Gloucester Lodge Design comparison report

Date
January 2020

Stage
Planning / Rev 00

This report is being submitted in support of a S73 and listed building consent application.

Proposed amendments to consented scheme
—
Basement

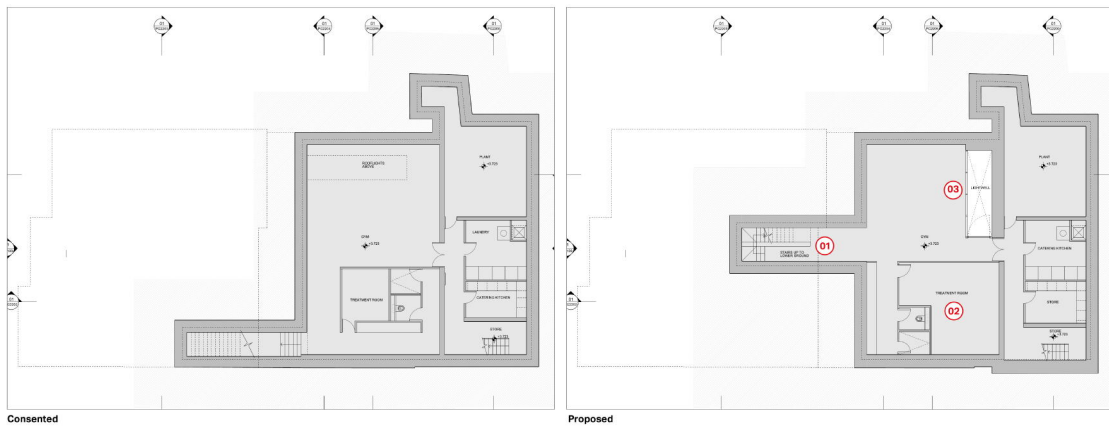
- 01 Relocation of the proposed stairs between the basement and lower ground floor to area below the existing stairs
- 02 Revision to layout of treatment room as a result of item (1)
- 03 Change from a rooflight to a lightwell and relocation of the opening towards the external wall of the mezz

Lower ground floor

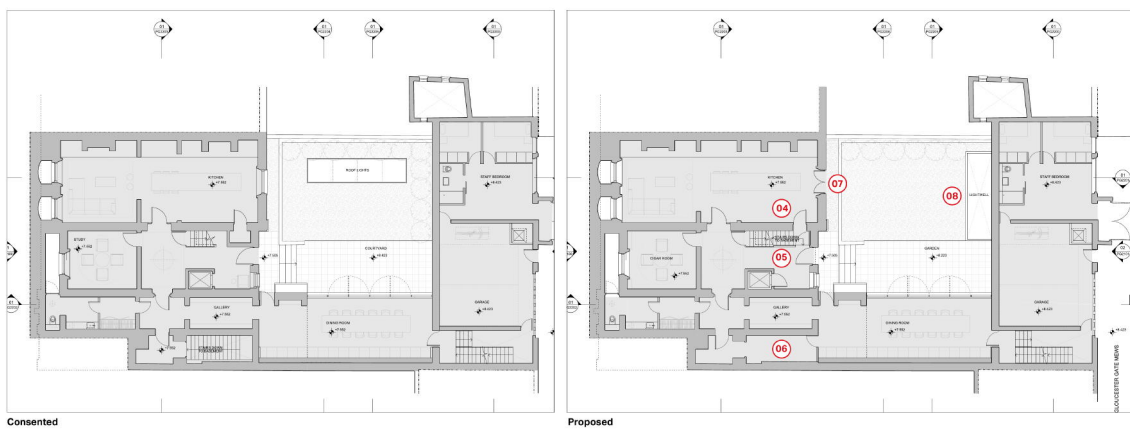
- 04 Removal of non-original cupboard under the existing stairs as a result of item (1)
- 05 Relocation of the proposed stairs between the basement and lower ground floor to area below the existing stairs, as per item (1)
- 06 Retention of the vaulted ceiling of the gallery as a result of item (5)
- 07 Lowering of the window opening in the kitchen to install a double door to the garden
- 08 Change from a rooflight to a lightwell and relocation of the opening towards the external wall of the mews, as per item (3)
